# TECHNICAL SERVICE BULLETIN

## Rattle From The Right Loadspace Trim Panel At High Audio System Volumes

**24-2387**

<b>Ford</b> 2021-2024 Bronco	Equipped with a factory subwoofer
---------------------------------	-----------------------------------

Figure 1

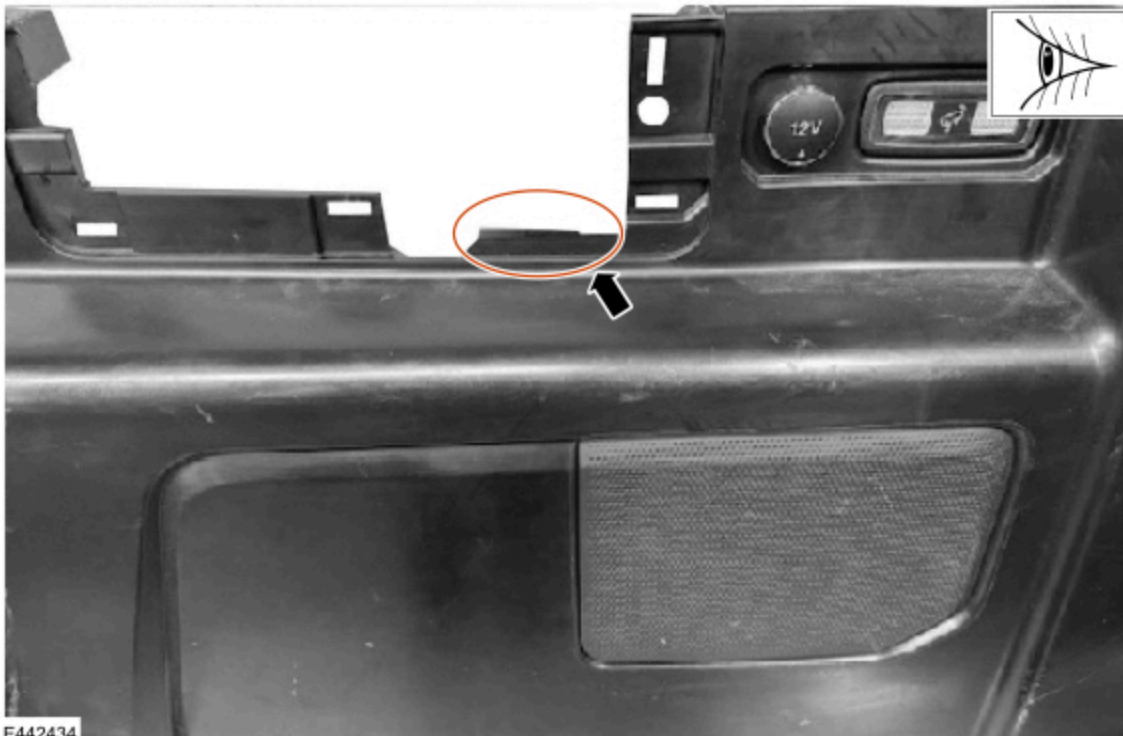
1. Remove the right loadspace trim panel. Refer to WSM, Section 501-05 Interior Trim and Ornamentation.
2. Trim the loadspace panel in the area shown in Figures 1-2.

Item	Description
1	0.25 in. (6.3 mm)
2	1 in. (25.4 mm)

Figure 3 - 3-door loadspace trim panel shown

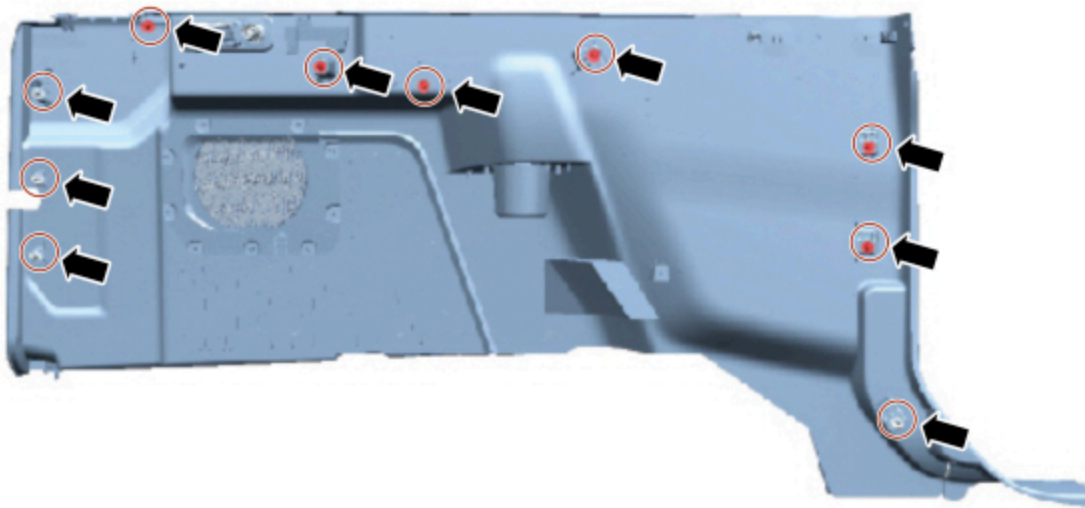
3. Replace all loadspace trim panel retaining clips. (Figures 3-4)

Figure 6

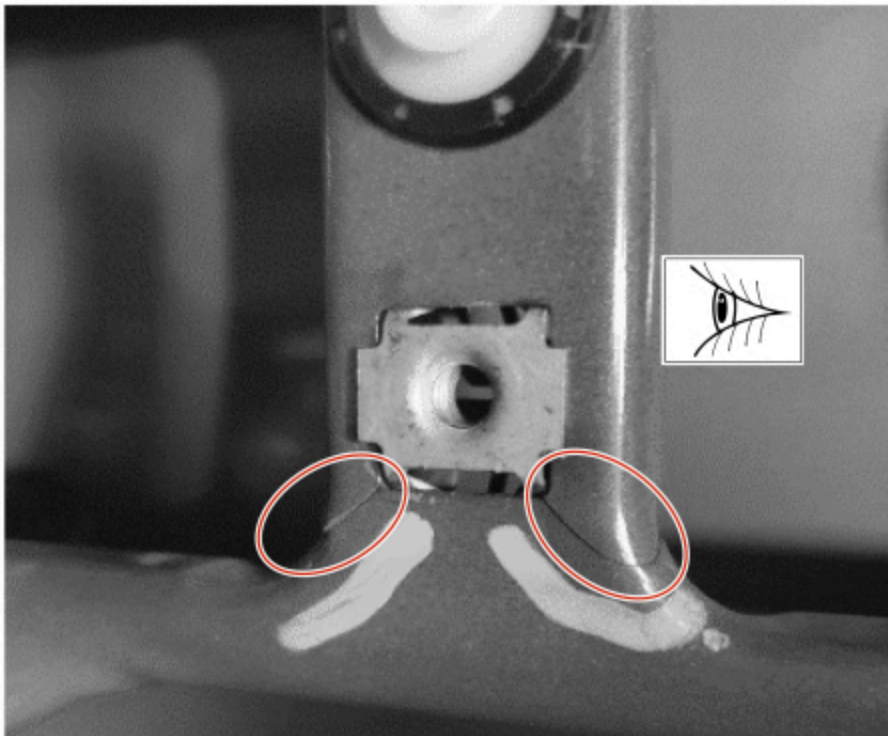
**6. Inspect the top mounting point of the subwoofer for a crack in the metal as seen in Figure 6. Is the metal mounting point cracked? (Figures 6-7)**

(1). Yes - proceed to Step 7 for the temporary repair and inform the customer that they will need to return at a later date when the permanent fix is available. Monitor PTS for updates.

(2). No - proceed to Step 8.

Figure 7

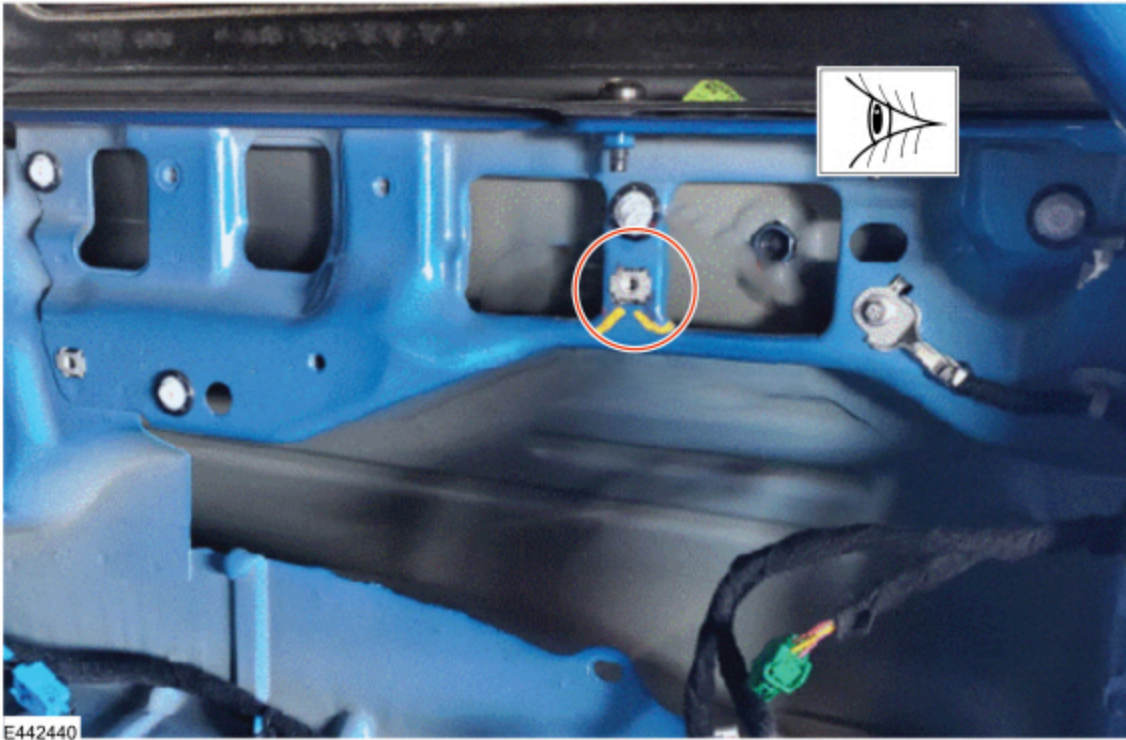
7. Remove and discard the retaining nut shown in Figure 7. Install the subwoofer using the original bolt but with additional washers and nut as shown in Figure 8. Tighten to 62 lb.in (7 Nm). Proceed to Step 9.

Figure 9 - left image shows metal retaining nut, right image shows rubber insulated retaining nut

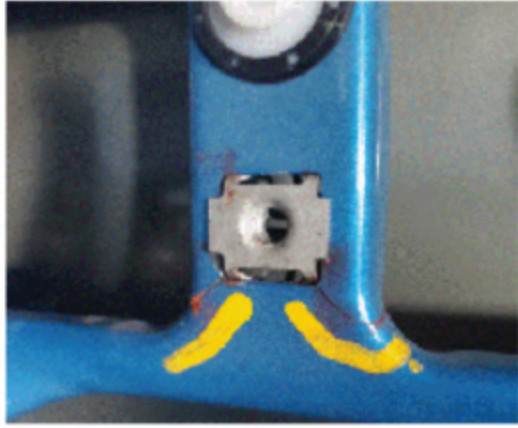
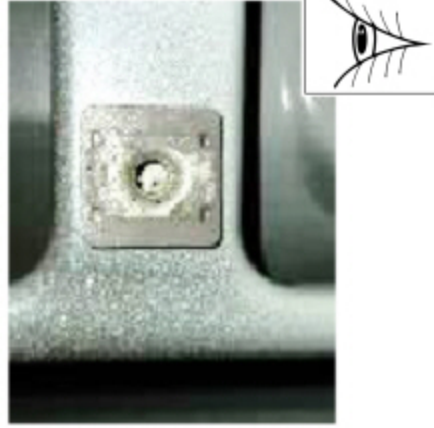
8. Replace the retaining nut. Refer to Figures 7 and 9.

**NOTE: The new retaining nut is rubber insulated, the factory retaining nut may be rubber or metal**
